Purpose of Report: *Post Renovation Building Defects Report*
Date of Inspection: 17th October 2005
Property Description: **4-5 Bed F.S Timber Framed Residence**
Address of Property: **Burrawang NSW**
Invoice No.
Client Name: Mr & Mrs. M
Building Consultant: Mr. Dominic Ogburn AMAIB Lic No BC 359
e-mail: info@accesspropertyservices.com.au
Office (02) 9798 5000 Fax (02) 9225 9656 Mobile 0418 865-663

On behalf of the client **Mr/s. M & L. M** I undertook a building survey of the subject **property** over one third of a day on **17/10/05**.

Marked up Architectural Plan *MB 04\01 A*

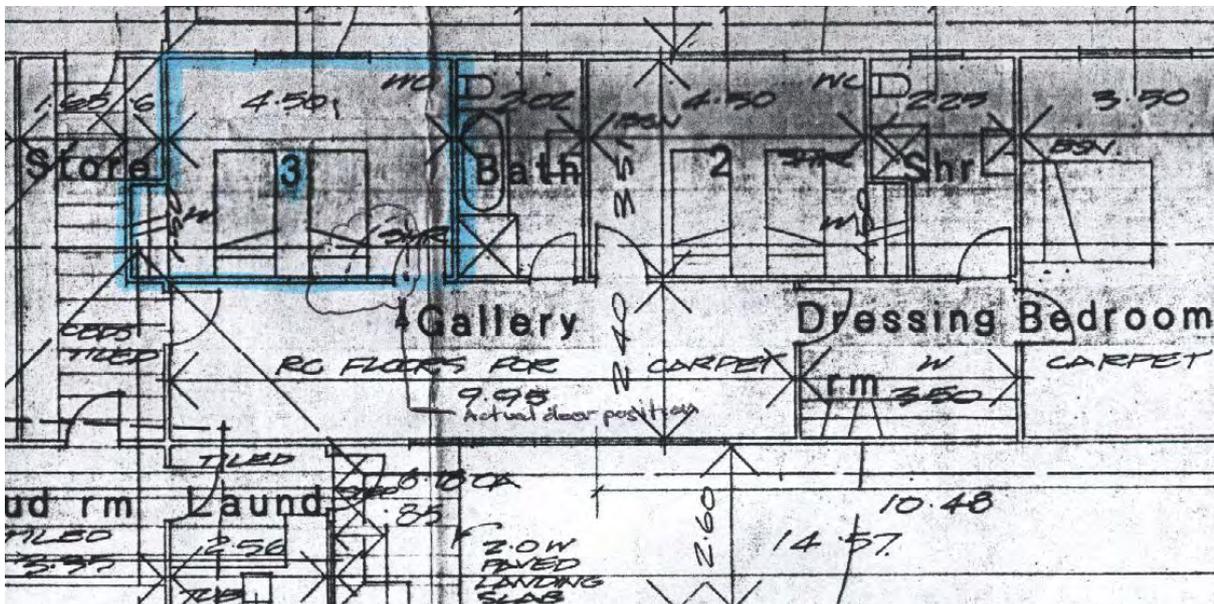
APS Contract review observations; Contract Architectural Drawing *MB 04\01 A* shows Bed 3 entry door to be located in the southern wall, hinged on the right hand side, and with no nib such that the door opens parallel and flush with the bathroom western wall and so as to permit locating to single beds centrally (as shown on plan) and as per the adjacent Bed2.

The builder has installed the Bed 3 entry such that there is a approx 500mm wide nib on the eastern side, which is contrary to the contract Architectural Drawing *MB 04\01 A* and as per the attached marked up Architectural plan (below), thereby denying the opportunity to install the single beds side-by-side in the location as shown on the drawing. *Refer Photo No12* on previous page.

In my professional opinion the builder is fully liable for this construction error and I recommend that the builder reposition the door as per the approved design on Architectural Drawing *MB 04\01 A* and reinstate wall and floor finishes and be fully liable for all associated costs.
